**DEVELOPMENT CONSENT AUTHORITY
DARWIN DIVISION**

AGENDA ITEM: **1** **MEETING DATE:** 03/07/2026 **FILE:** PA2026/0165

APPLICATION PURPOSE:	Dwelling-multiple (14 x 2 bedroom) in a three storey building
SUBJECT SITE:	Lot 1861 (85) Progress Dr, Nightcliff, Town of Nightcliff
ZONE:	MR (Medium Density Residential)
SITE AREA:	1740 m ²
APPLICANT	Cunnington Rosse Town Planning and Consulting Senior Planning Consultant - Rory Mackay
PERSONS ON WHOSE BEHALF THE APPLICATION IS MADE	Landowner
LANDOWNER	Tsougranis Developments Pty Ltd Director - Paul Tsougranis
ANY PERSON WITH AN AGREEMENT TO ACQUIRE AN INTEREST IN THE LAND	None

STORM SURGE IMPACT - PRE DEVELOPMENT

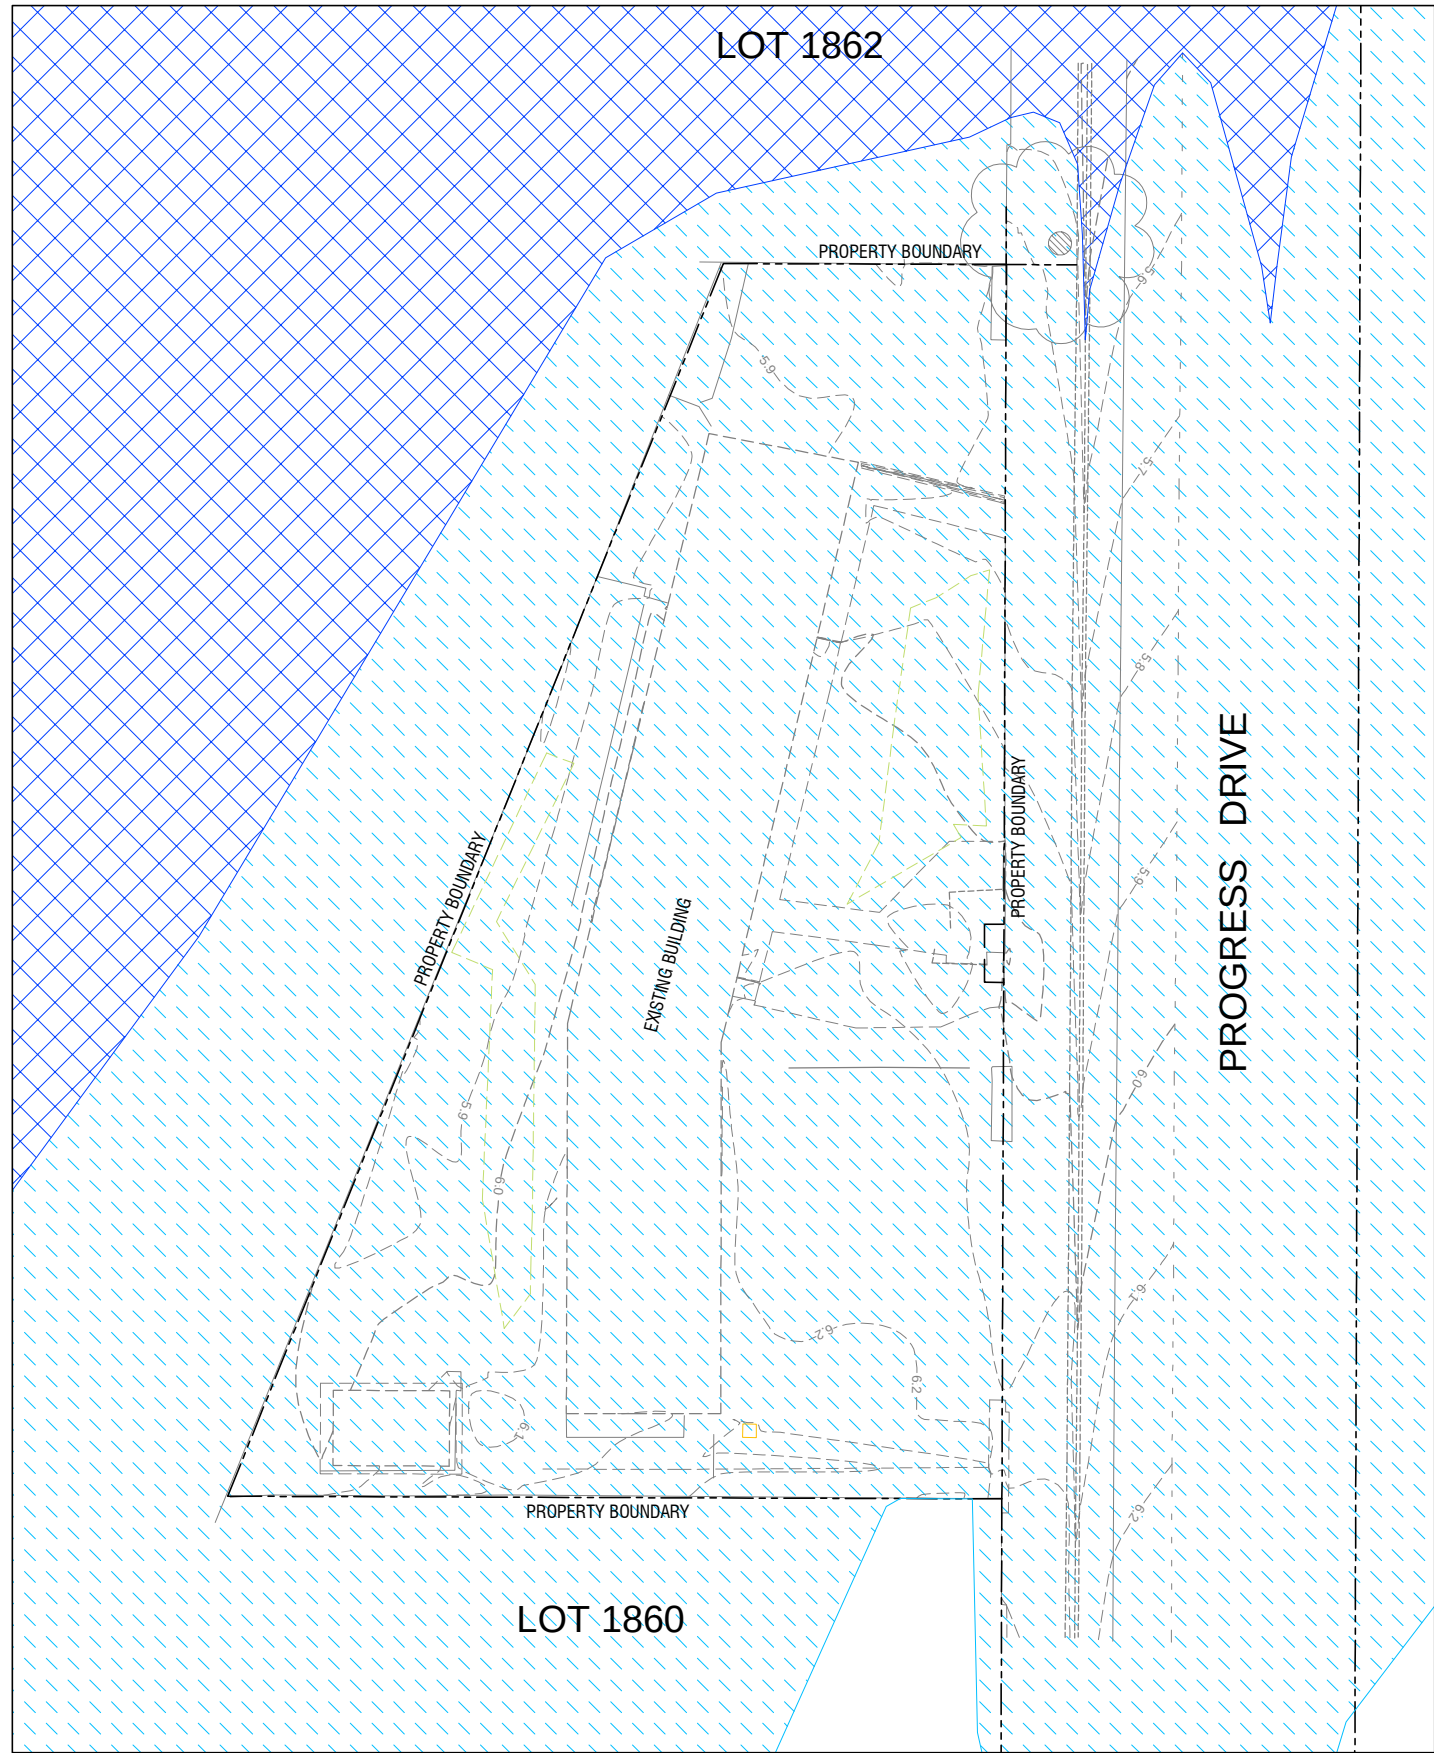
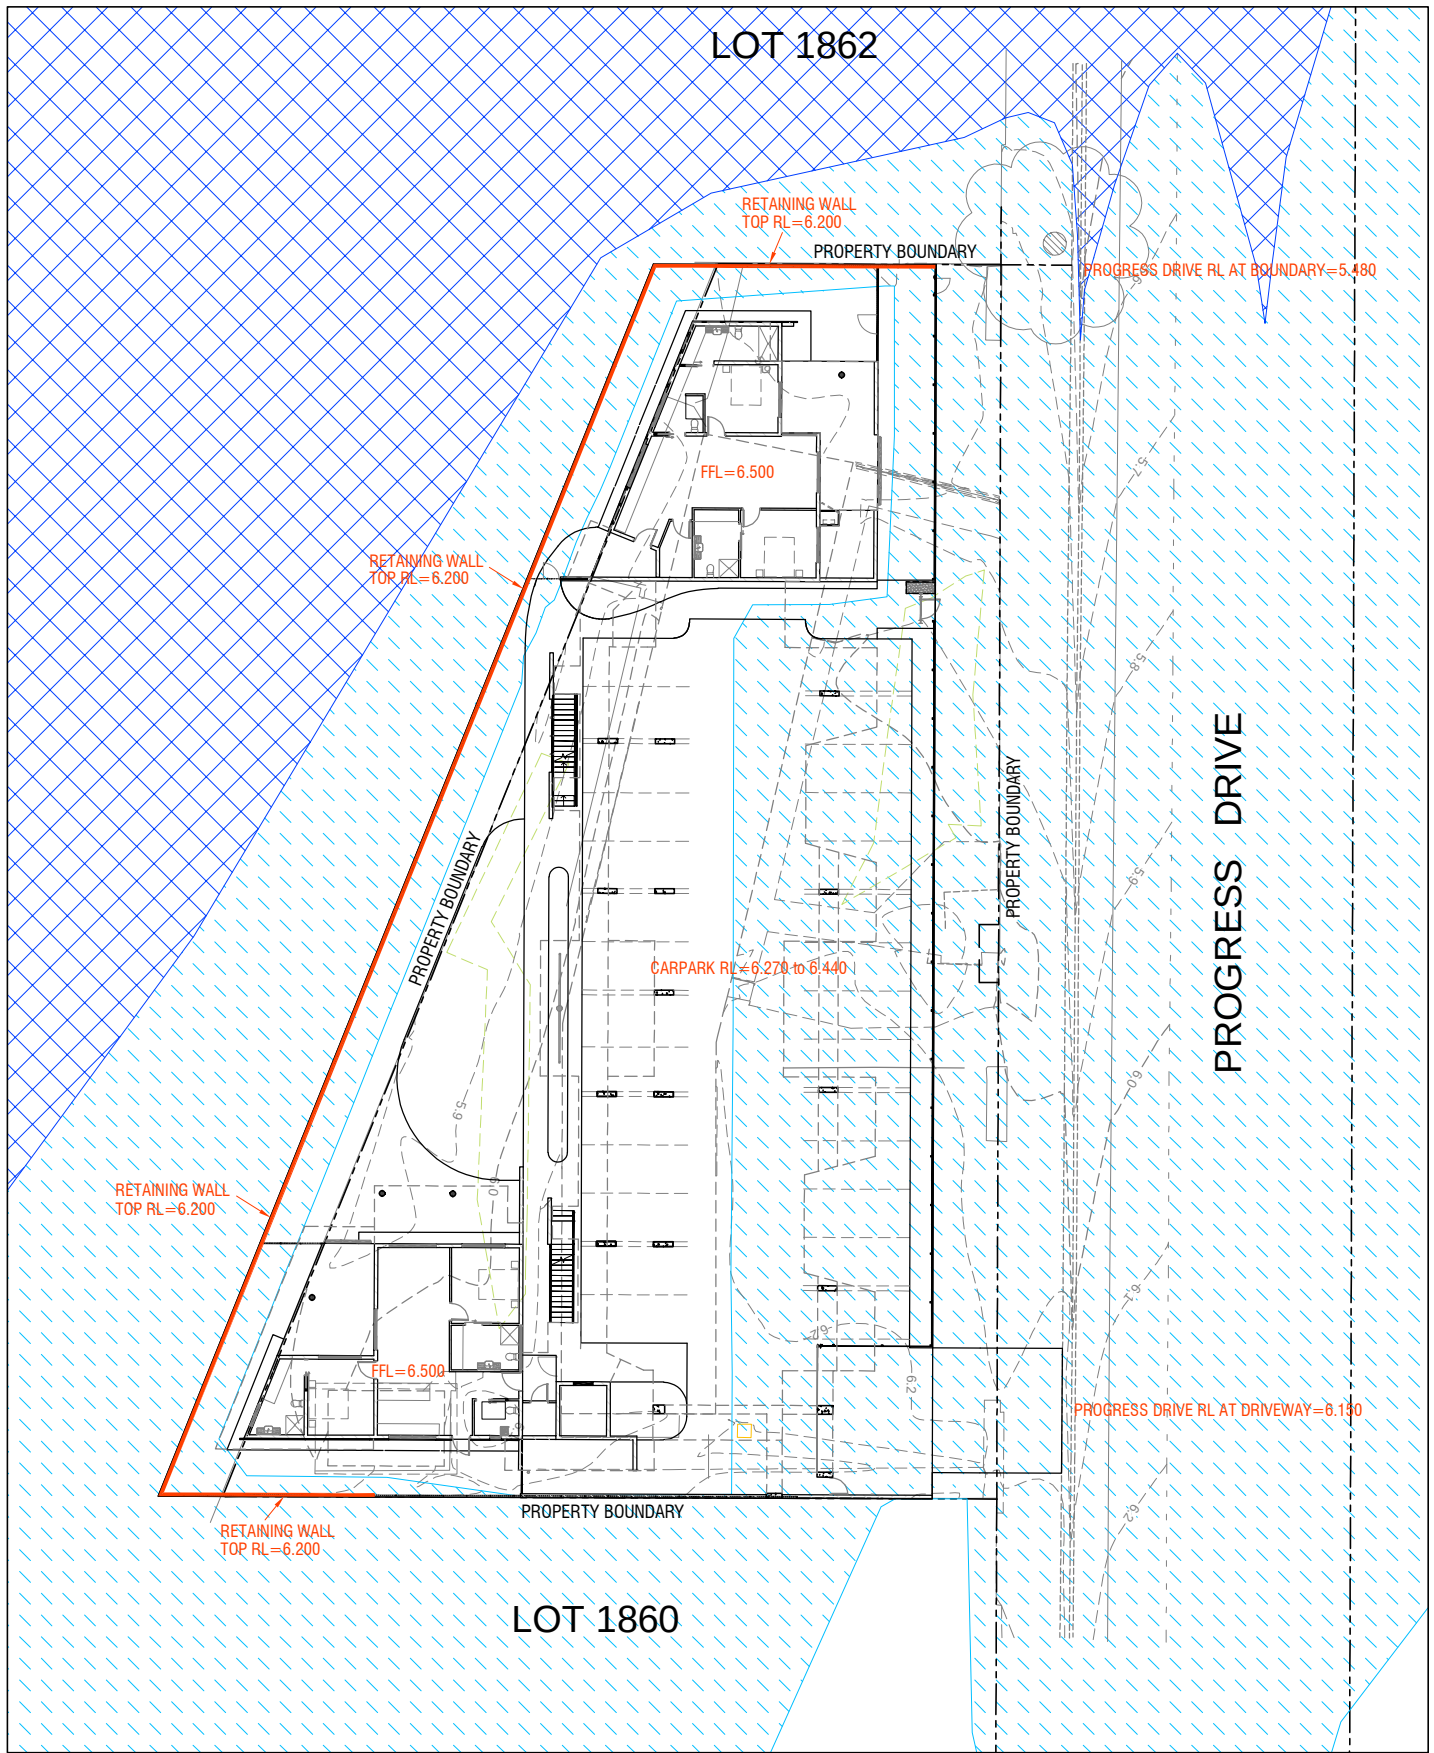
The proposed finished floor level (FFL) for all ground-level habitable areas (2 of 14 units) will be 6.5 m AHD, which is above the secondary storm surge zone (SSSZ). Accordingly, the risk associated with secondary storm surge inundation to habitable areas is effectively mitigated. The proposed car park will be partially located below the secondary storm surge level; however, it remains trafficable during such an event. The maximum projected depth of inundation is approximately 120mm at the lowest point of the pavement. Figure 1 below illustrates the pre- and post-development storm surge impacts (primary storm surge inundation shown in dark blue and secondary storm surge in light blue).

Figure 6: Proposed Communal Open Space

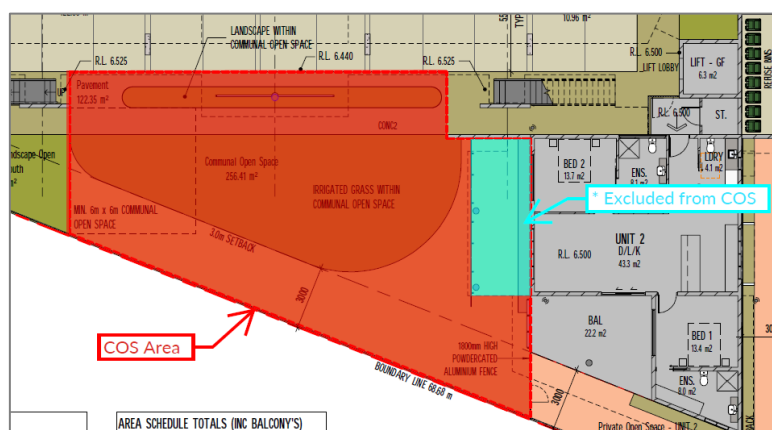
It is noted that the annotated communal open space area of 256.41m² includes the 17.5m² area between the privacy screen and Unit 2, which may not be readily accessible or usable as communal open space. Therefore, this assessment excludes that area from the communal open space calculation. Refer to Figure 6 below:

B	FRONT BOUNDARY EGRESS GATES MOVED TO OPEN WITHIN BOUNDARY; FRONT FENCE RELOCATED AROUND ELECTRICITY EASEMENT	17.06.26
A	ISSUED FOR DA APPLICATION	07.05.26
ISSUE	AMENDMENT	DATE

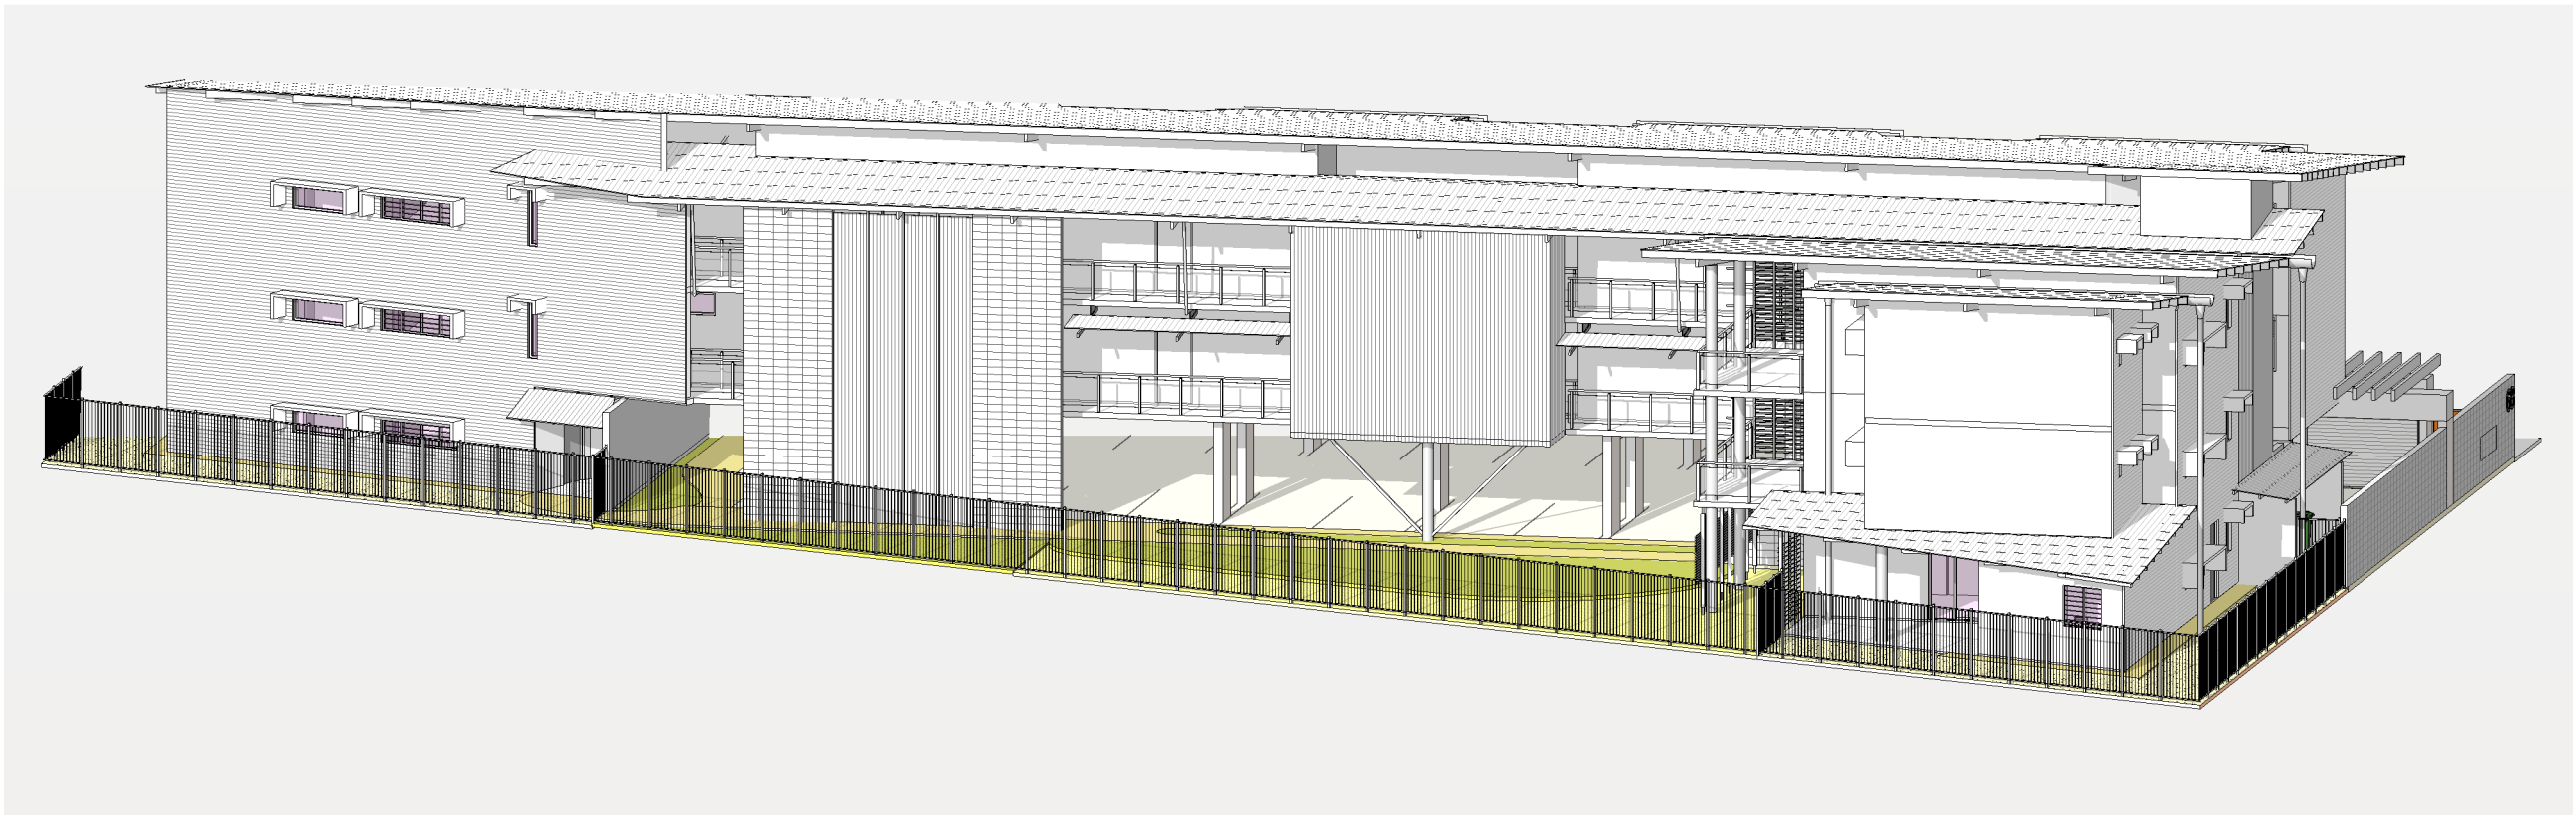
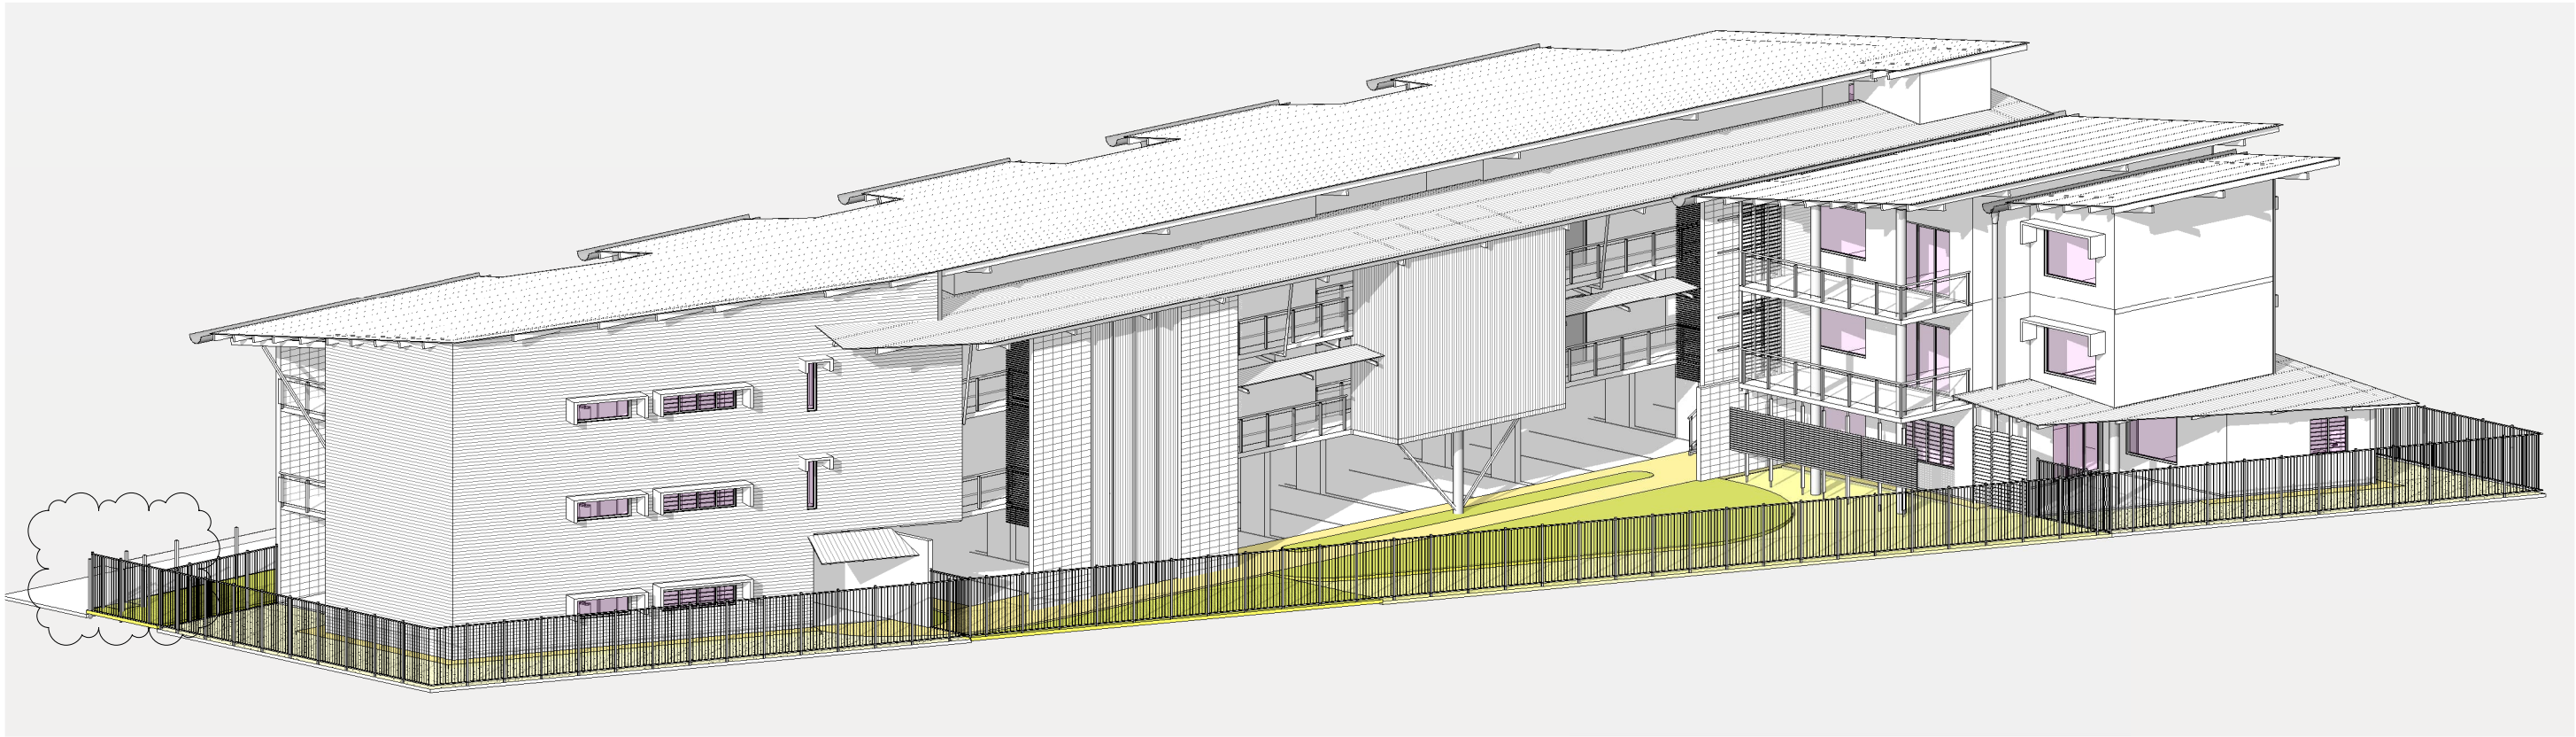
- The proposed crossover width exceeds the standard 6m requirement and requires justification.
- The proposed egress gate should be revised to open inward, as outward-opening gates onto the road reserve are not supported.
- The proposed Alexander Palms may be spaced too closely considering their long-term growth, and increased planting distances are required.
- The proposed Murraya Paniculata may impact passive surveillance and CPTED outcomes, therefore alternative species are recommended.
- A minimum 400mm setback is required between the footpath edge and boundary fencing for pedestrian amenity and maintenance access.

4. The proposed 1.5m high fence blocking the 24hr front access to current two Distribution Pillars P272NC and P276NC pillars for PWC operations and maintenance purposes is strictly prohibited. TDPL shall re-submit a revised Site Plan (Sheet No.1014 – DA02) showing the proposed 1.5m high fence around the electricity easement, leaving the front boundary clear.
